From: [Avitabile, David](#)
To: ["Ndaw, Mamadou \(DCRA\)"](#)
Cc: ["LeGrant, Matt \(DCRA\)"; Epting, John; "Ilan Scharfstein"](#)
Subject: 2121 M Street (B1310607) - Response to Zoning Review Comments
Date: Sunday, November 10, 2013 12:32:25 PM
Attachments: [RE 2121 M Street -- Review of our discussion.msg](#)
[2121 M Street -- Review of our discussion.msg](#)
[Determination Ltr re 2109 M St to Epting 12-6-2010.pdf](#)
[At-Grade Connections.pdf](#)
[Valet Parking Plan.pdf](#)
[Hyatt Place M Street Rooftop Structures .pdf](#)
[Hyatt Place M St Site Plan - loading.pdf](#)

Zoning Comments for 2121 M ST NW - B1310607

Hyatt Place Hotel
2121 M Street, NW
Washington, D.C. 20036

ROOF TERRACE PLAN

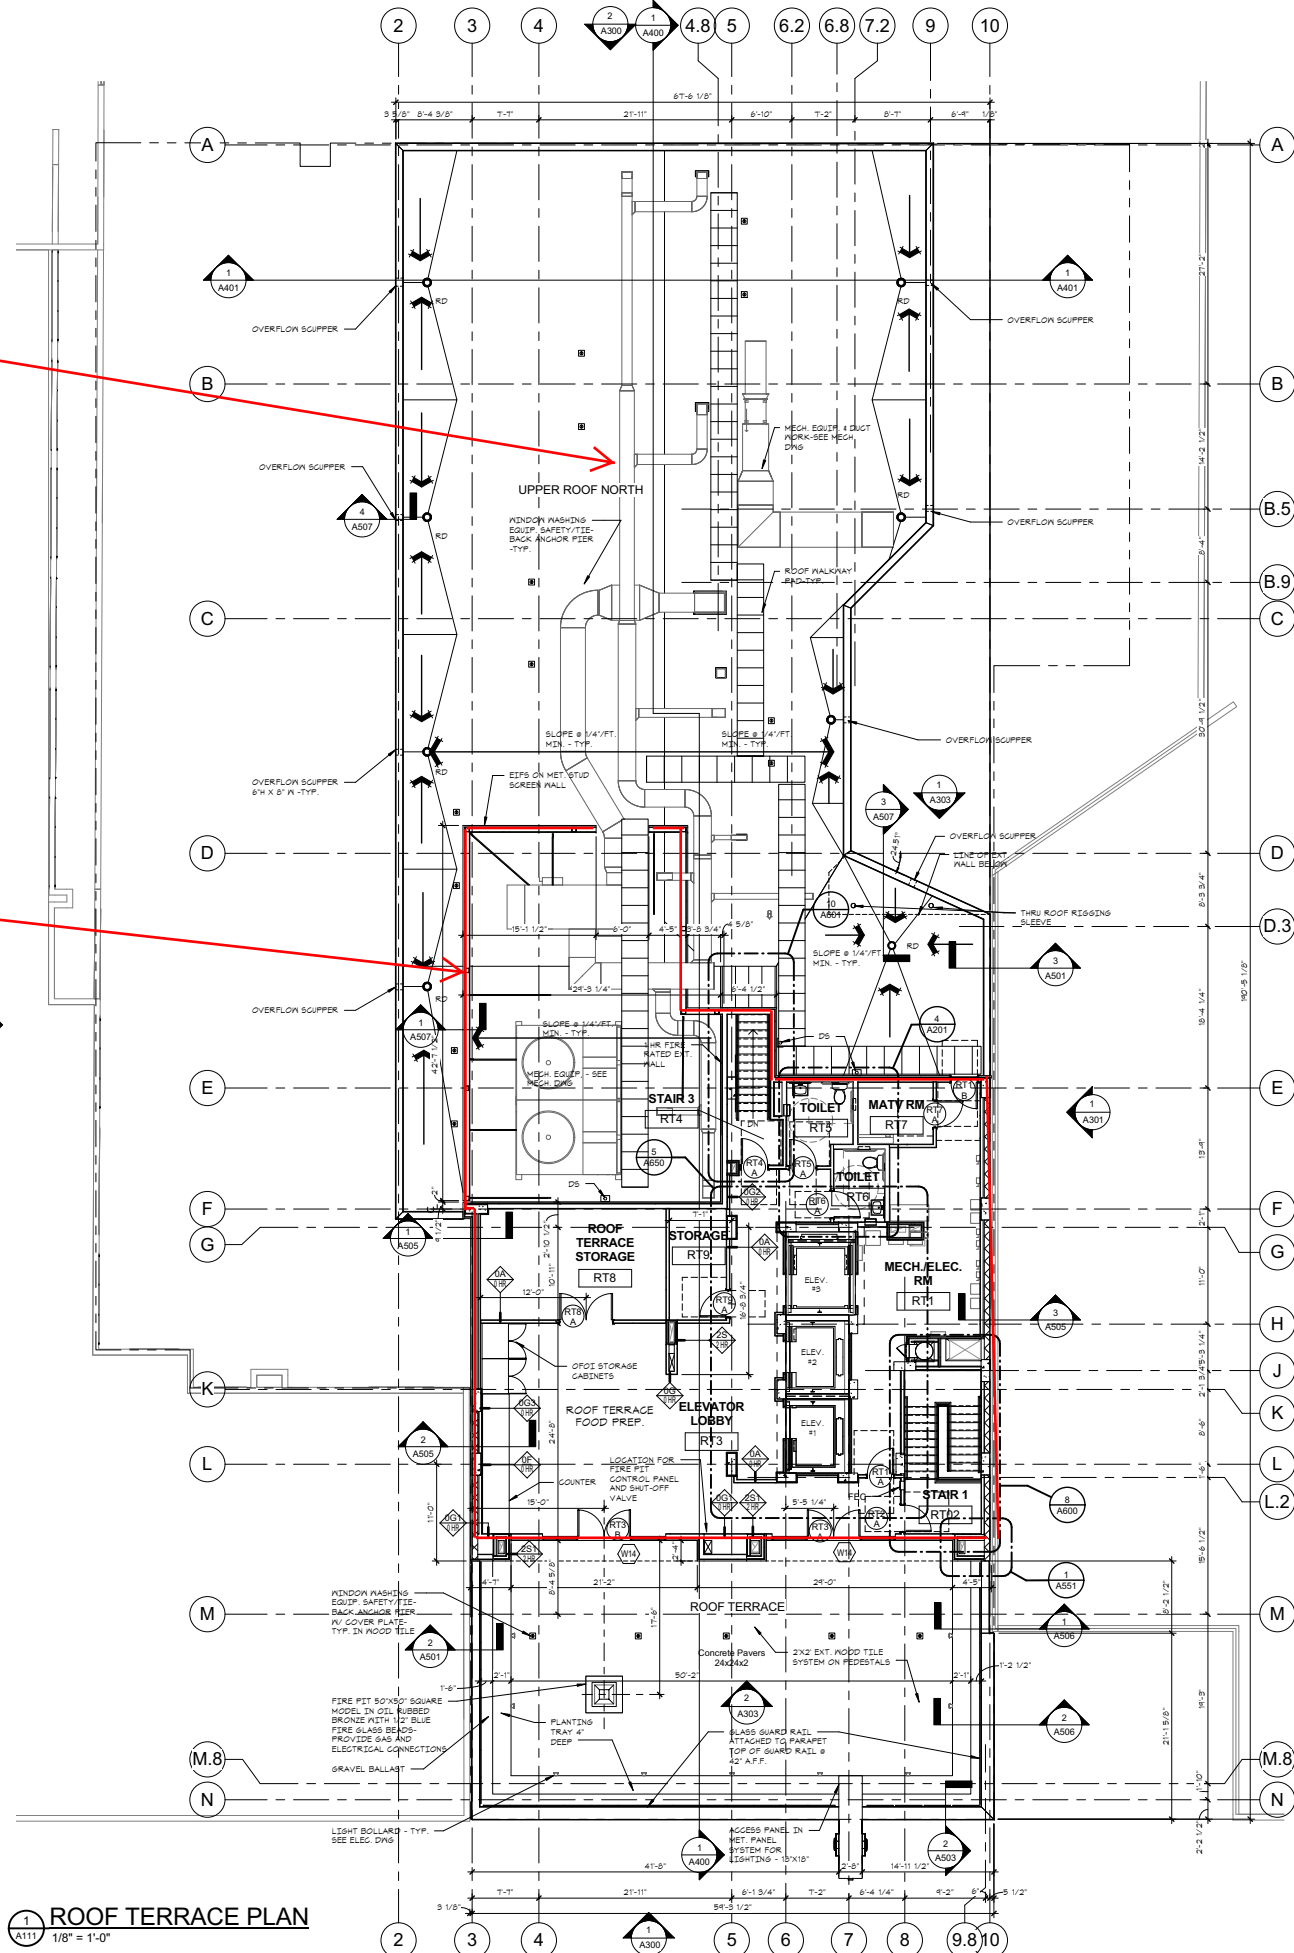
8. Please check for compliance with §411.3 enclosure for rooftop structures.

Attached is an exhibit that shows the outline of the roof structure. As you can see, all rooftop mechanical equipment and penthouses greater than 4 feet in height are within a single enclosure of equal height. The remaining equipment is all less than 4 feet in height and therefore not subject to the requirements of Section 411. (See Section 411.17.)

ALL OTHER STRUCTURES SHOWN ON THE ROOFTOP, NOT WITHIN THE ENCLOSURE, ARE LESS THAN 4' ABOVE THE ROOF.

RED LINES INDICATES ROOFTOP STRUCTURE (SCREEN WALL) ENCLOSING MECHANICAL EQUIPMENT. MAXIMUM HEIGHT IS 18'-6" ABOVE UPPER ROOF ELEVATION
